SUBJECT: Forwards response to 830915 request for addl info re control room habitability per NUREG-0737,Item III.D.3,4.

H. B. ROBINSON STEAM ELECTRIC PLANT, UNIT NO. 2  
DOCKET NO. 50-261  
LICENSE NO. DPR-23  
NUREG-0737 ITEM III.D.3.4  
CONTROL ROOM HABITABILITY

FIGURE 3-1  
EXISTING CONTROL ROOM HVAC FLOW DIAGRAM

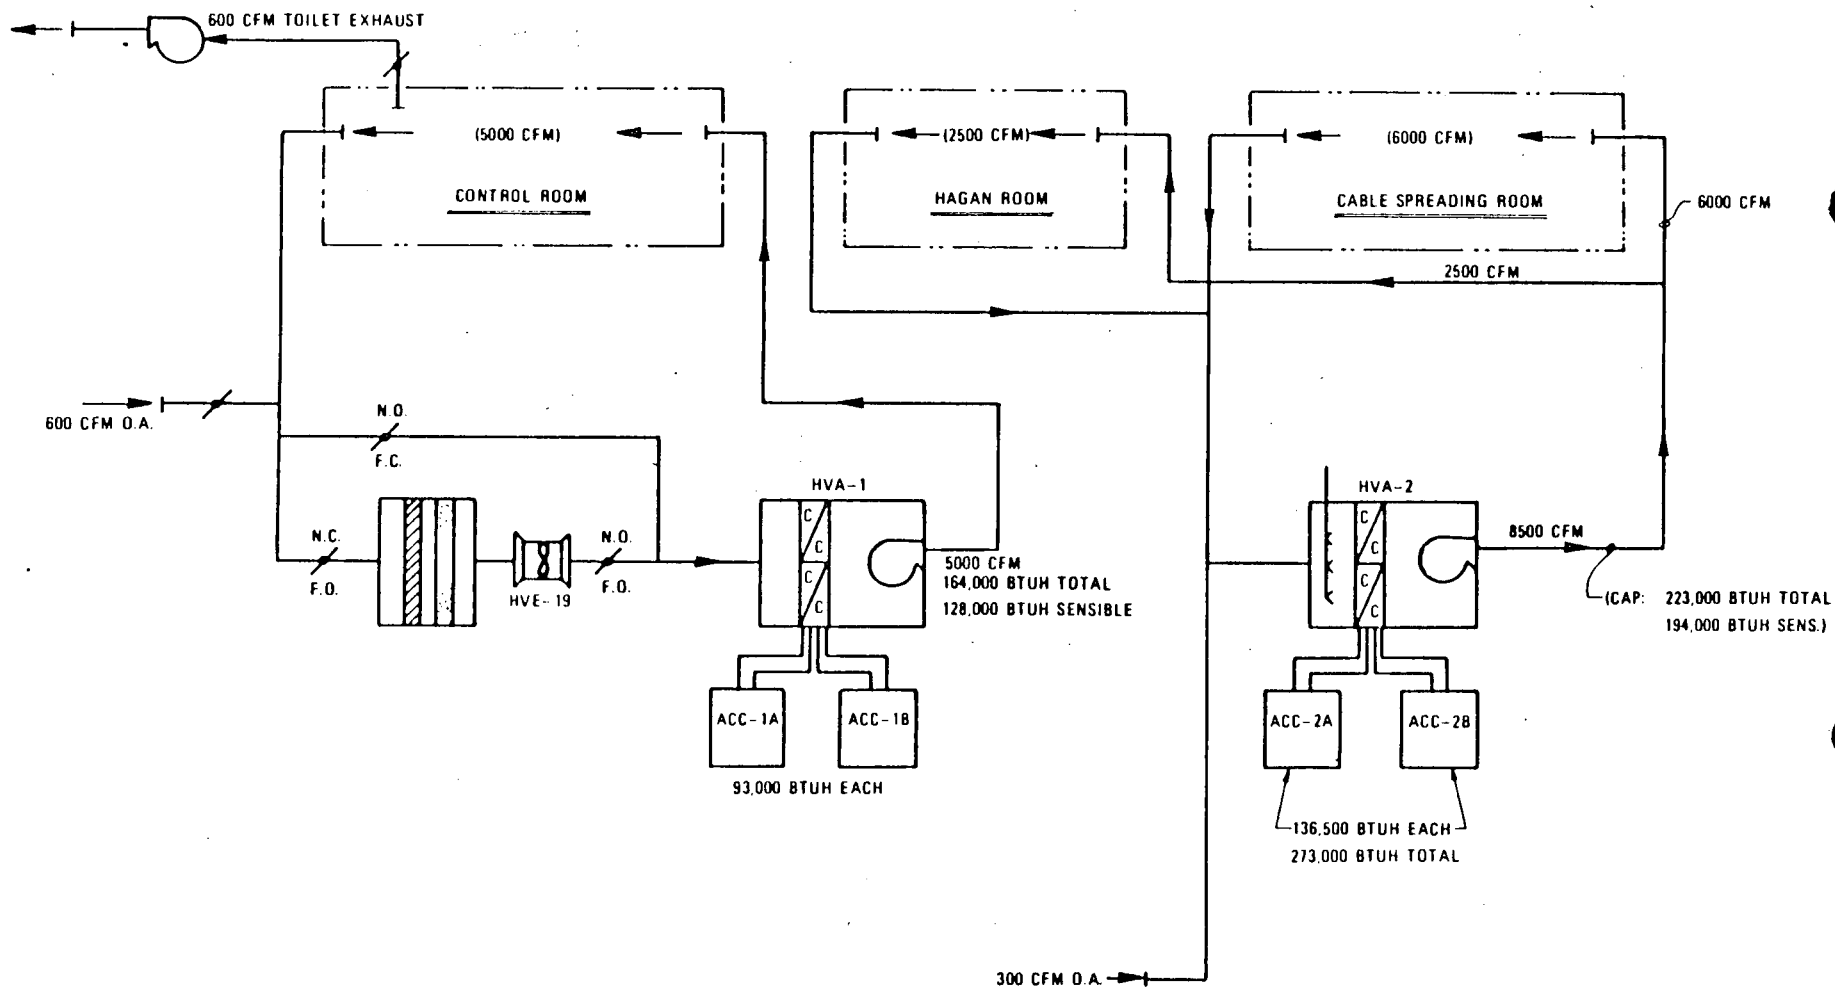
- a. The free volume of the increased control room emergency zone.
- b. Schematic drawings showing the location of control and fire dampers, radiation monitors, filters and fans, with normal and emergency flows and estimated leakages for all ducts and volumes indicated.

- b. Schematic drawings showing the location of control and fire dampers, filters and fans with normal and emergency flows, estimated leakage for all ducts, and room volumes are provided in Figure 3-1 and Figure 4-1 for the existing Control Room HVAC System. Drawings showing the proposed modification to the Control Room HVAC System are provided in Figure 4-2 and Figure 4-3. The ability to detect, filter, and discharge airborne contaminants in the Control Room is described in our June 2, 1983 submittal (Section A.2.5 in Table A-1).
